CITY OF MAPLE PLAIN

PLANNING COMMISSION STAFF REPORT

Highway 12 Equinox Townhomes

Rezoning to PUD • Planned Unit Development • Site Plan Review • Preliminary & Final Plat

Exhibit A – Highway 12 Sidewalk Connection, Conceptual Alignment Prepared by the City

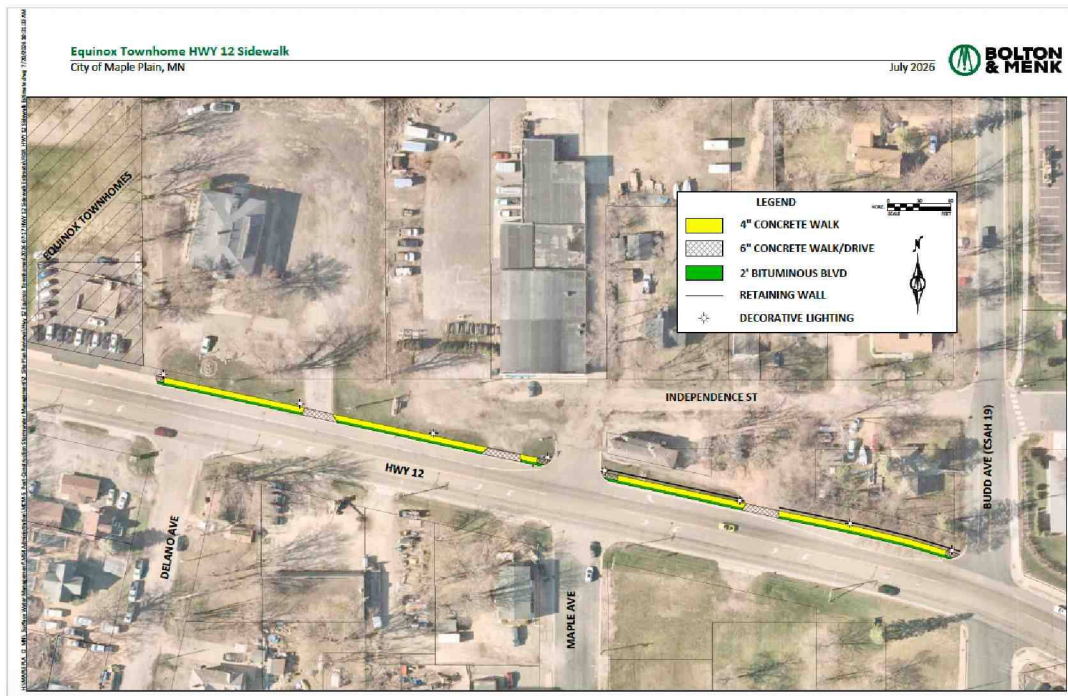
#	City Comment	Applicant Response / Proposed Solution
1	Highway 12 Sidewalk Connection - The City would like to see the sidewalk connection installed along Highway 12, consistent with prior discussions with the Applicant's design team. The City has prepared an exhibit illustrating a potential connection alignment and associated estimated construction cost (see Exhibit A, below). - Please revise the plan set to include this sidewalk connection. The City would also like to further discuss the parties' respective responsibilities for the design, construction, and cost of this improvement at the time of resubmittal.	COMMENT REMAINS OPEN Per discussions with the Owner and City, this sidewalk connection will be shown on later versions of the plans. The city is in agreement with this solution and is working with the developer to obtain MNDOT approval and also is considering funding that would help realize this connection.

Exhibit B – Recommended Sidewalk Alignment, Buildings C.1 & C.2 Parallel Parking Area

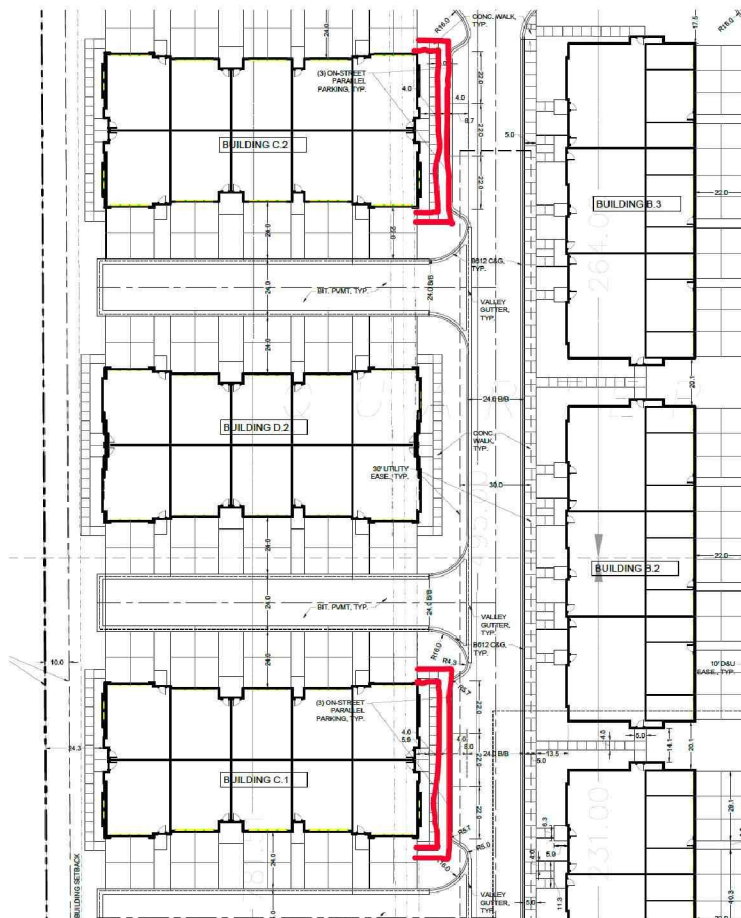
#	City Comment	Applicant Response / Proposed Solution
2	Sidewalk Alignment – Buildings C.1 and C.2 The sidewalk located along the east side of Buildings C.1 and C.2 does not align with the parallel parking spaces directly adjacent to it. Staff recommends shifting this sidewalk segment so that it abuts the parking spaces, allowing residents and guests to step directly from a parked vehicle onto the sidewalk rather than into the drive aisle (see Exhibit B, below).	Sidewalks updated to align with the parallel parking areas as recommended.
